CITY OF
SARATOGA SPRINGS

Planning Commission Meeting
Thursday, March 13, 2014
Meeting held at the Saratoga Springs City Offices
1307 North Commerce Drive, Suite 200, Saratoga Springs

**Concept Plan
Green Springs
March 13, 2014
Public Meeting**

1 PRELIMINARY SITE PLAN
SCALE (24x36): 1" = 20'
SCALE (11x17): 1" = 40'

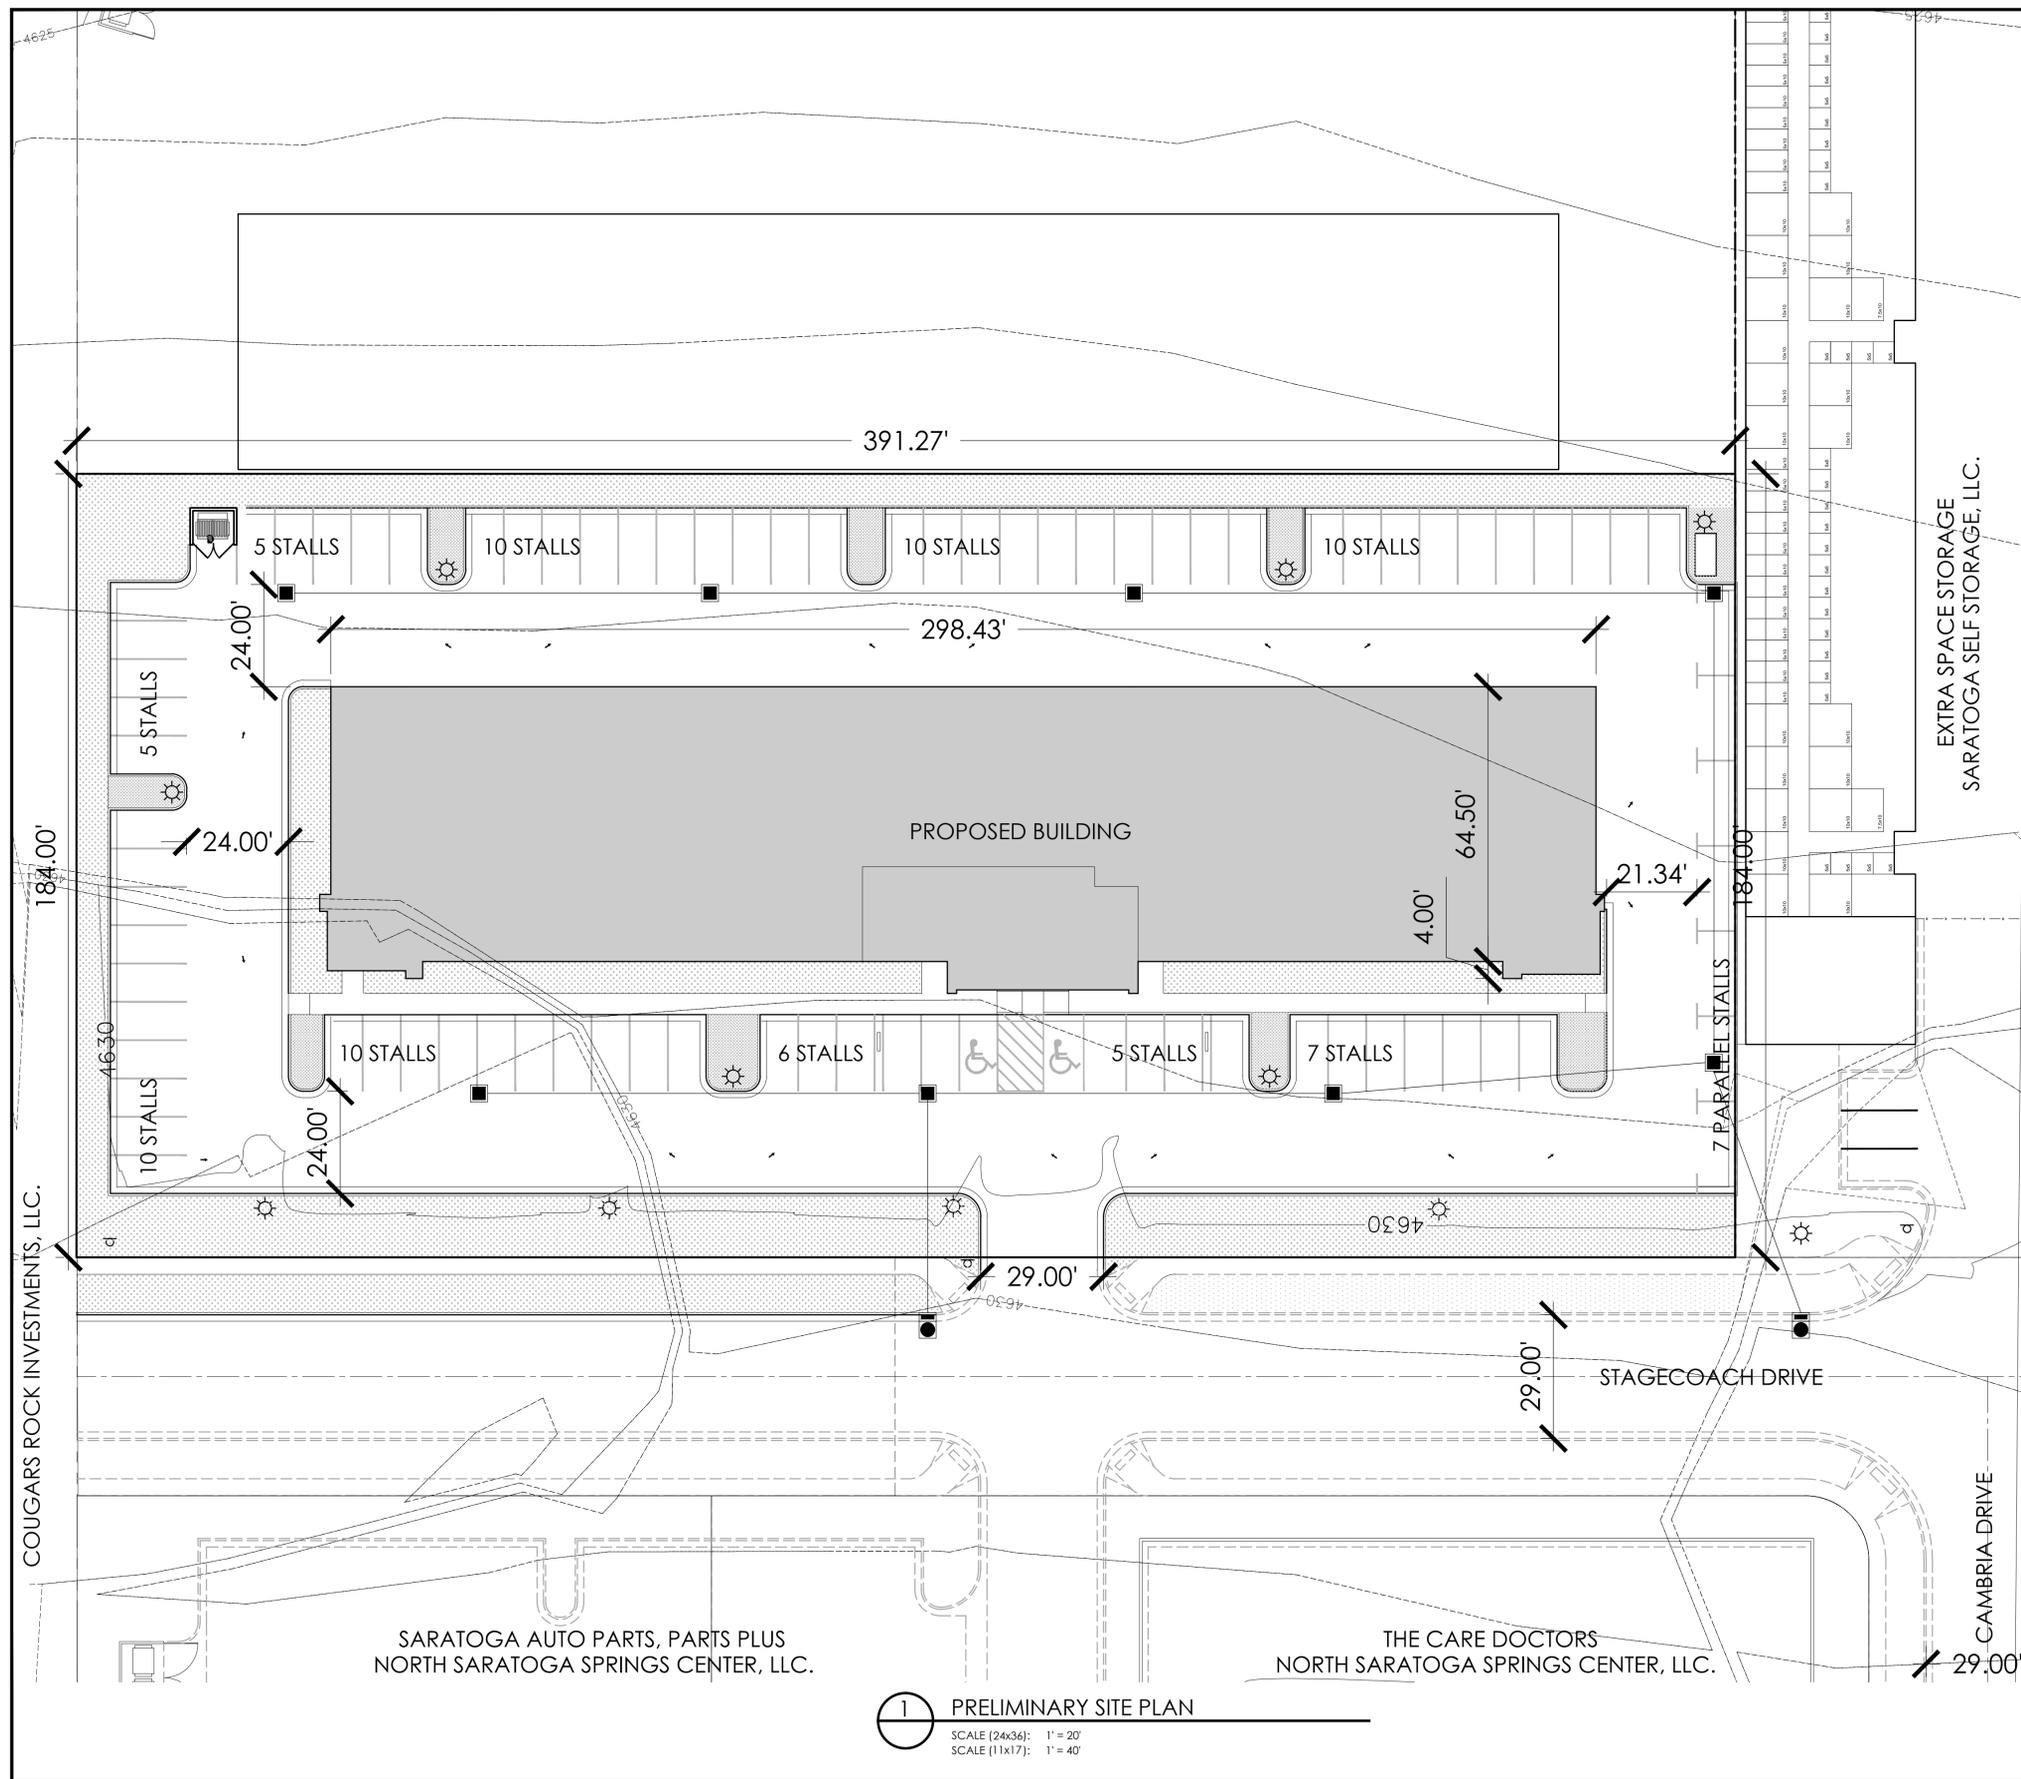
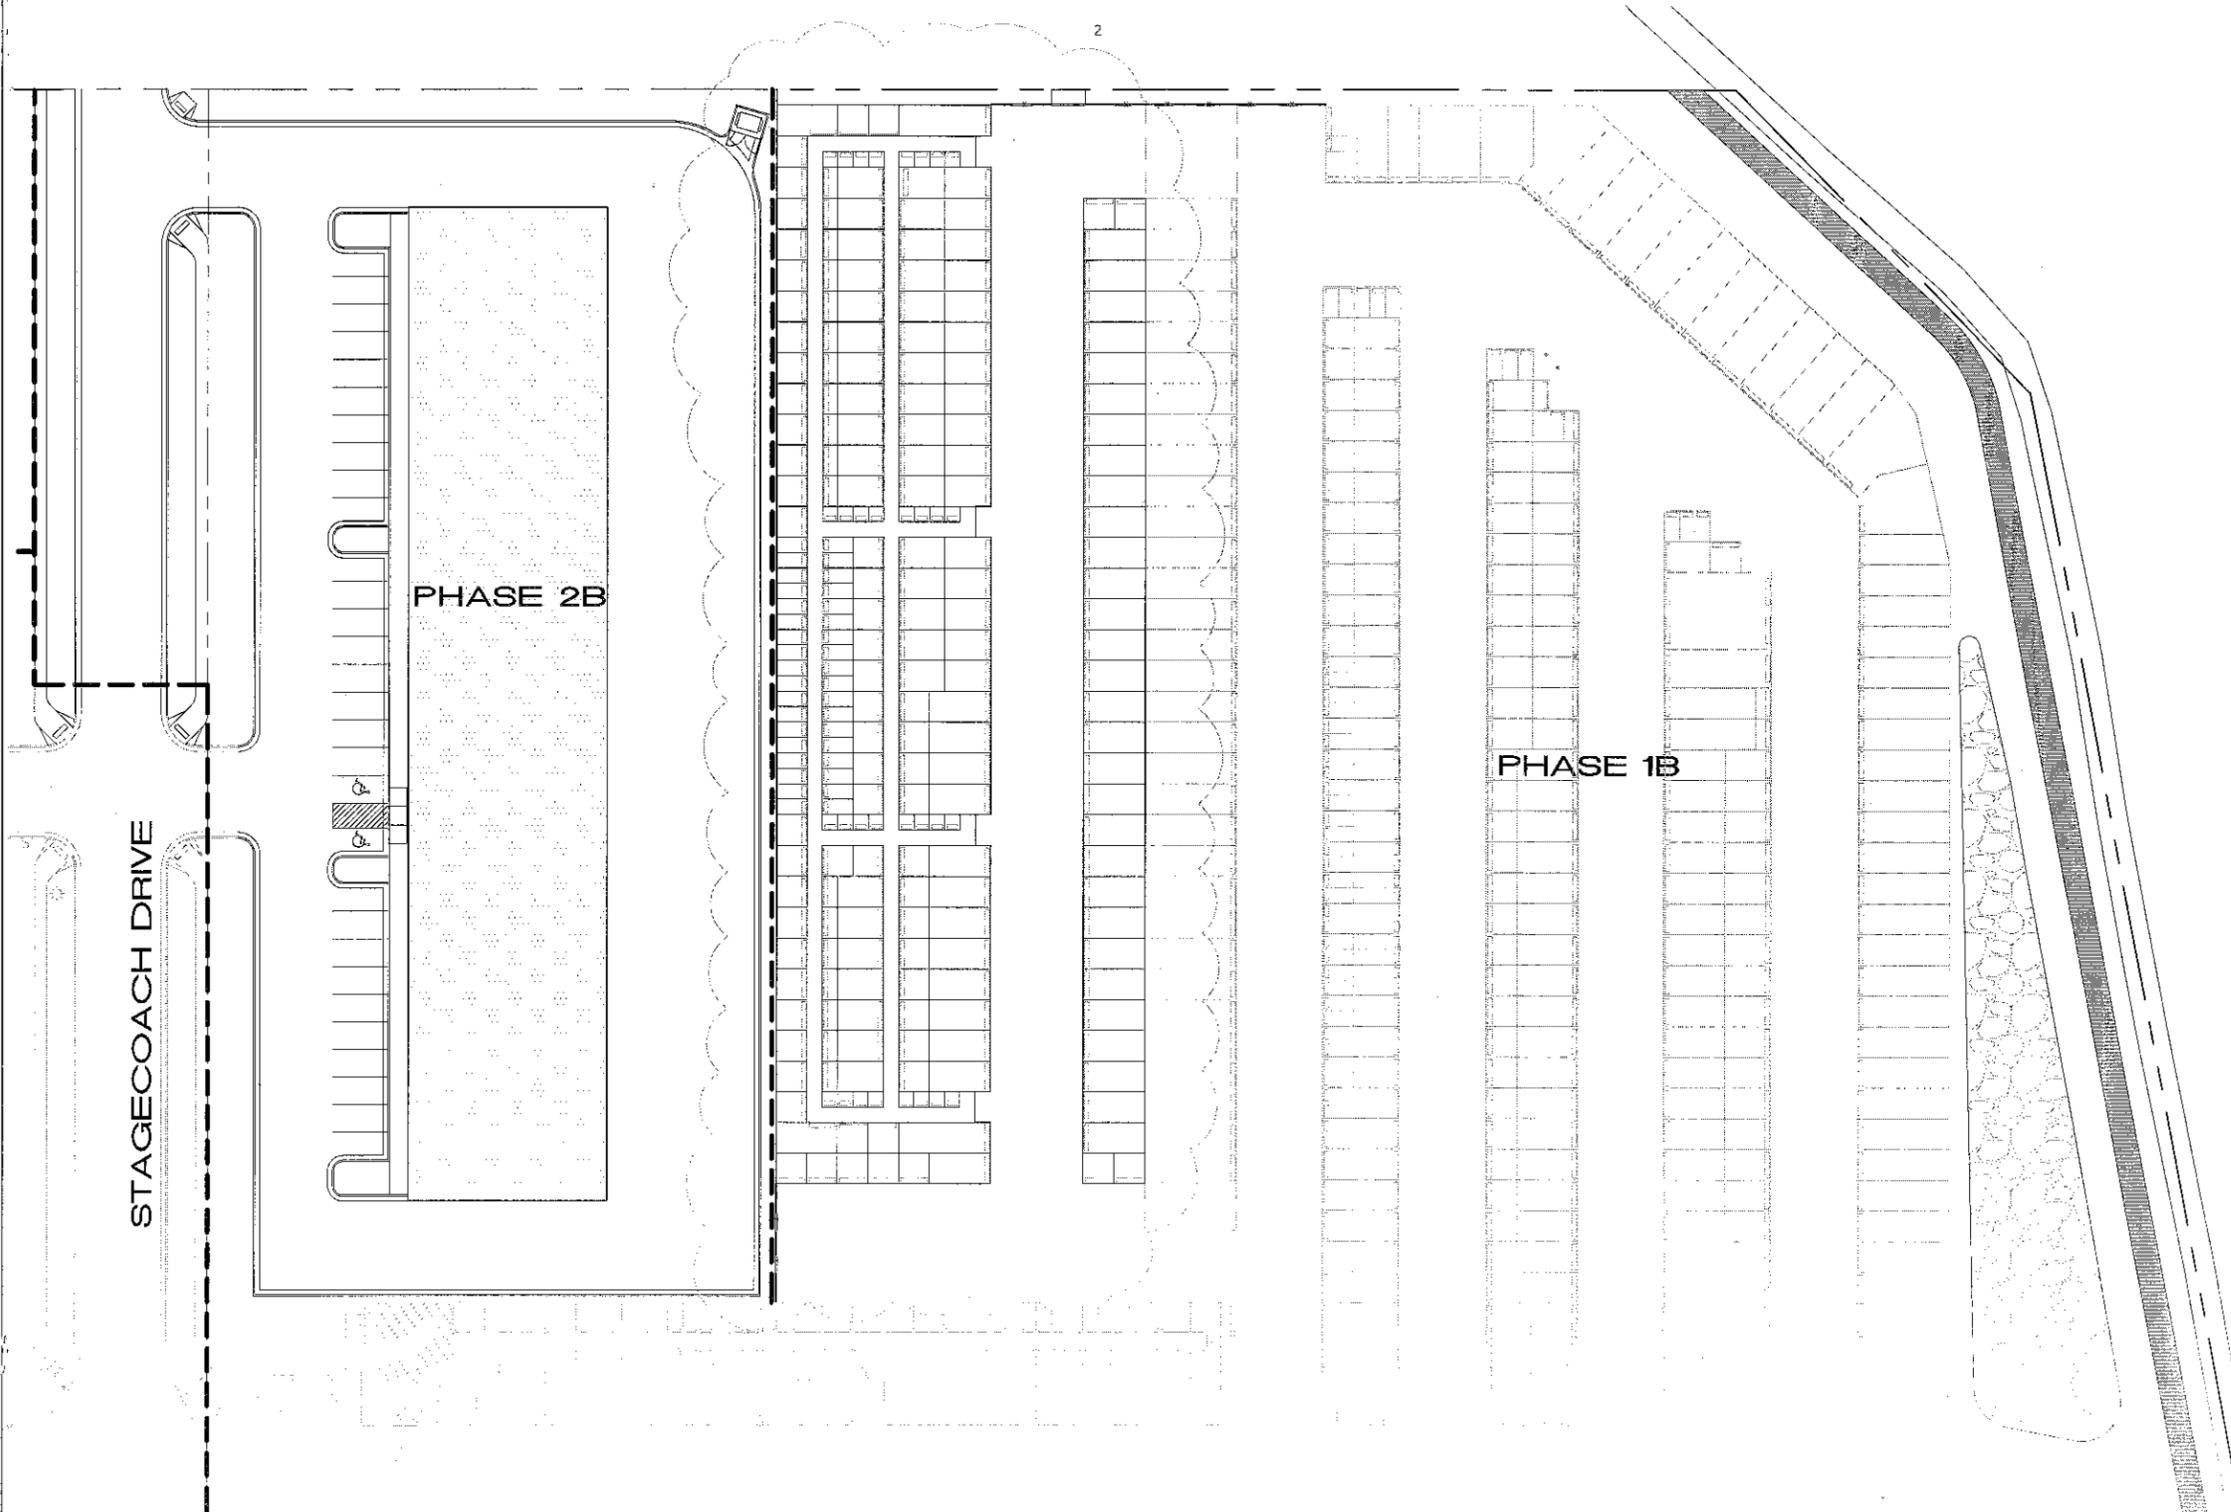
The applicant has provided a total 85 parking stalls, knowing that this is below what the code currently requires. They have done so, to raise the question about the appropriateness of the City's current parking standards.
